**Product Change Notification / CENO-280WHW230**

CCB 6054 Final Notice: Implement top marking changes for WBZ451PE-I and WBZ451UE-I catalog part numbers (CPN) available in 39L Module (15.5x20.7mm) package.

**CCB 6054**  
**Pre and Post Change Summary**  
**PCN #: CENO-280WHW230**

# MARKING CHANGE SUMMARY

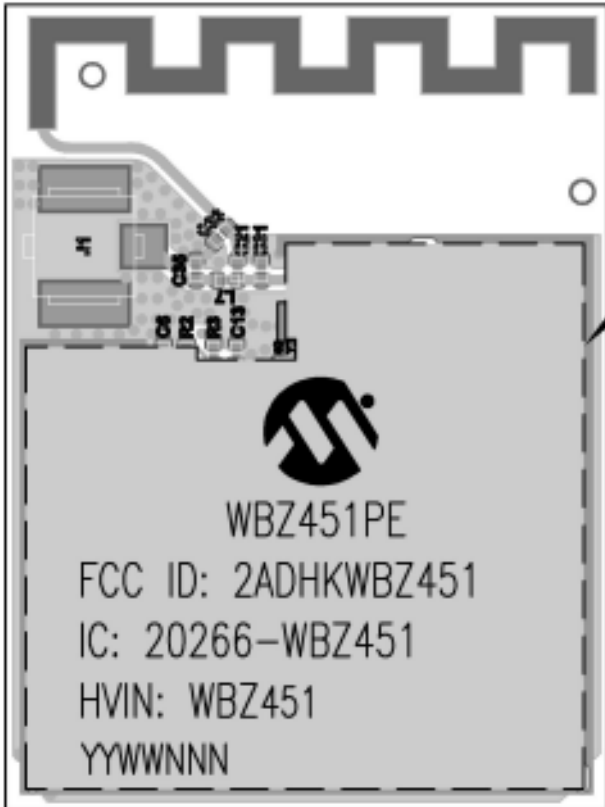
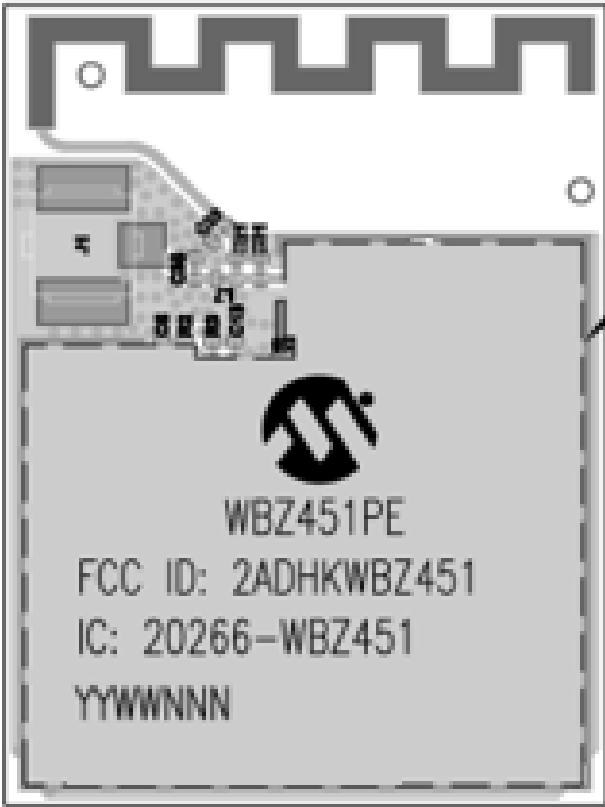
Pre Change	Post Change
WBZ451PE-I	 <p>WBZ451PE FCC ID: 2ADHKWBZ451 IC: 20266-WBZ451 HVIN: WBZ451 YYWWNNN</p>	 <p>WBZ451PE FCC ID: 2ADHKWBZ451 IC: 20266-WBZ451 YYWWNNN</p> <ul style="list-style-type: none"><li>- Removing Line5 marking <b>HVIN: WBZ451</b></li><li>- Line6 marking <b>YYWWNNN</b> will move up to line 5 position</li></ul>

# MARKING CHANGE SUMMARY

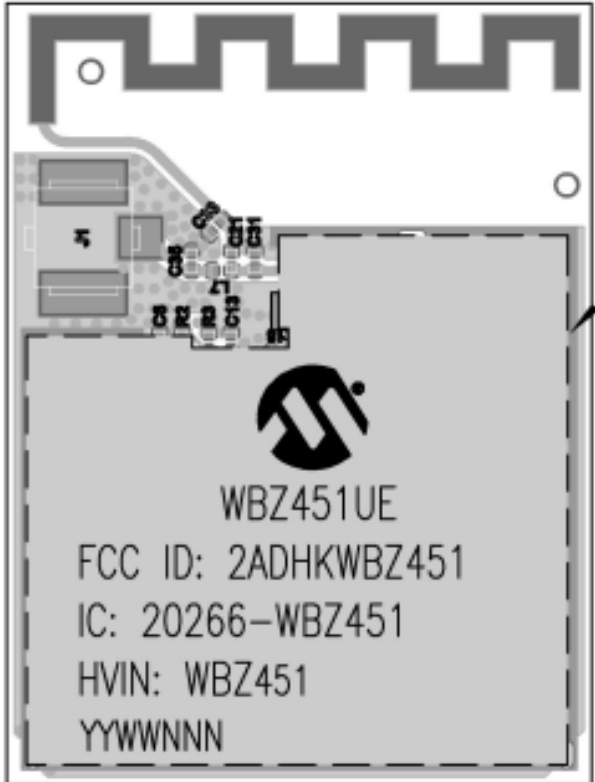
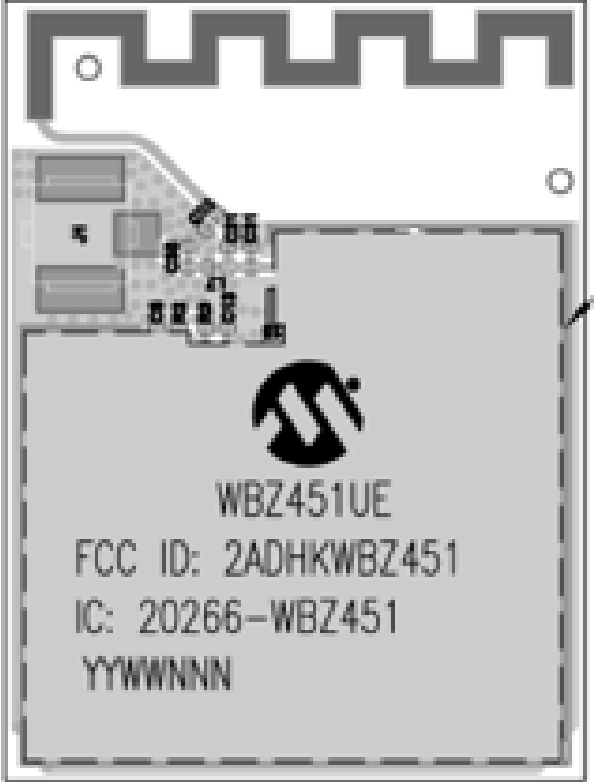
Pre Change	Post Change
WBZ451UE-I	 <p>WBZ451UE FCC ID: 2ADHKWBZ451 IC: 20266-WBZ451 HVIN: WBZ451 YYWWNNN</p>	 <p>WBZ451UE FCC ID: 2ADHKWBZ451 IC: 20266-WBZ451 YYWWNNN</p> <ul style="list-style-type: none"><li>- Removing Line5 marking <b>HVIN: WBZ451</b></li><li>- Line6 marking <b>YYWWNNN</b> will move up to line 5 position</li></ul>
